For a CSR applied bulk carrier, the continuous horizontal stiffener provided at non-watertight A, B & C - Girders is 150x11F.B.
Continuous horizontal stiffener provided at watertight C.L. - Girders is 350x100x11/17I.A.(HT32).

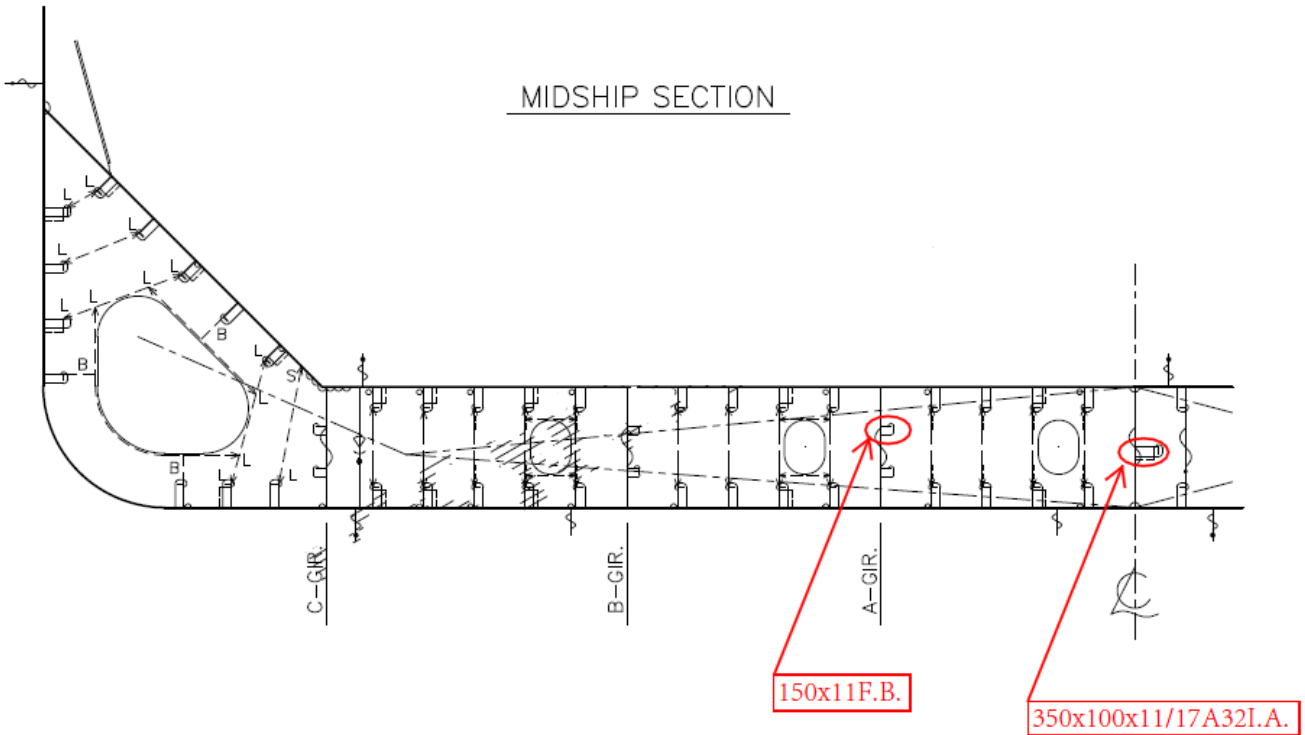
1. Stiffeners on A,B&C - Girder are considered as longitudinal stiffeners or web stiffeners?
2. Stiffener on C.L. - Girder are considered as longitudinal stiffener or web stiffener?

So far, three classifications gave three different answer to Question 1.
I hope final explain from IACS.
